May 23, 2002 NRC-02-0036

- Subject: Proposed Technical Specification Change (License Amendment) -<u>Response Time Testing</u>

# REQUEST TO RELAX RESPONSE TIME TESTING FOR REACTOR PROTECTIONS SYSTEM AND PRIMARY CONTAINMENT ISOLATION INSTRUMENTATION TECHNICAL SPECIFICATIONS

# **PROPOSED TS MARKED UP PAGES**

Primary Containment Isolation Instrumentation 3.3.6.1

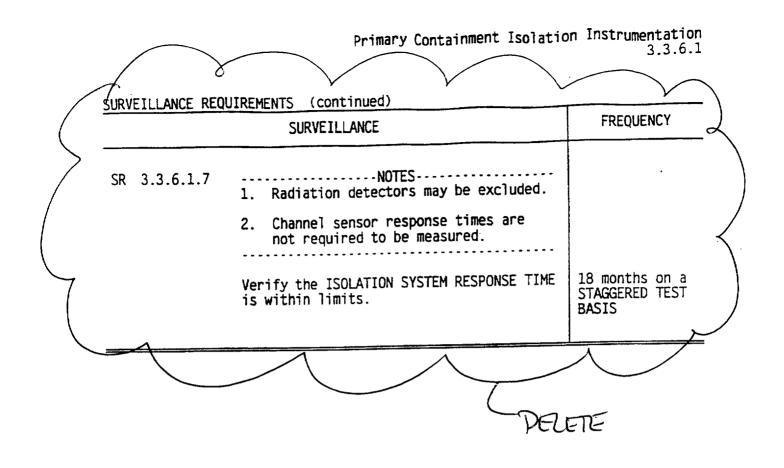
- Remove reference to Surveillance Requirement (SR) 3.3.1.1.17 from Table 3.3.1.1-1, Functions 3 and 4. This proposed change eliminates the requirement to perform response time testing for Reactor Protection System (RPS) Instrumentation- reactor vessel water level-low, level 3 and reactor vessel steam dome pressure high.
- Delete note 2 from SR 3.3.1.1.17. This change removes instructions that will no longer be applicable with the implementation of the Proposed Change.
- Remove reference to Surveillance Requirement (SR) 3.3.6.1.7 from Table 3.3.6.1-1, Functions 1.a and 1.c. This proposed change eliminates the requirement to perform response time testing for Primary Containment Isolation Instrumentation- reactor vessel water level-low low low, level 1 and main steam line flow-high.

• Delete SR 3.3.6.1.7. This SR will no longer be applicable with the implementation of the Proposed Change.

Primary Containment Isolation Instrumentation B 3.3.6.1

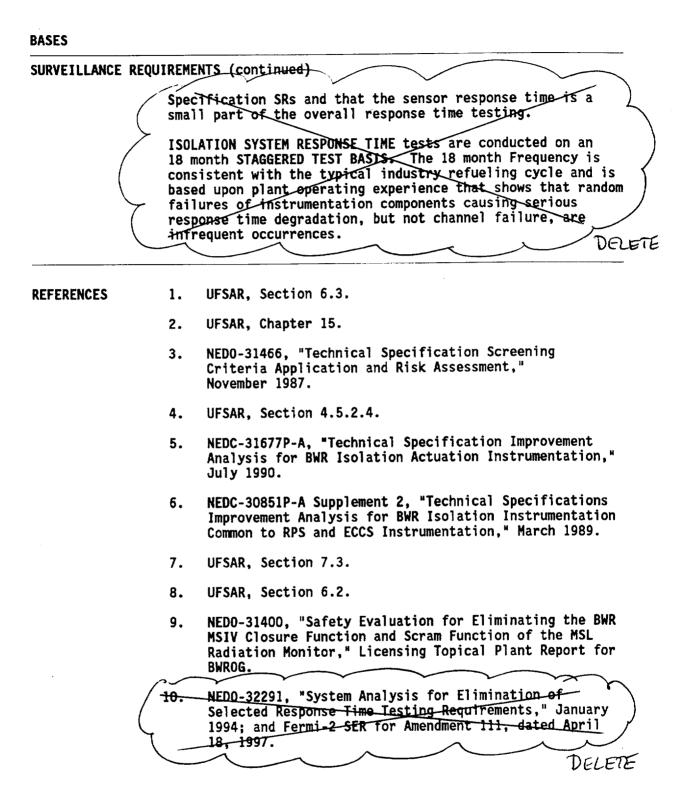
This SR ensures that the individual channel response times are less than or equal to the maximum values assumed in the accident analysis. The instrument response times must be added to the PCIV closure times to obtain the ISOLATION SYSTEM RESPONSE TIME.

DELETE
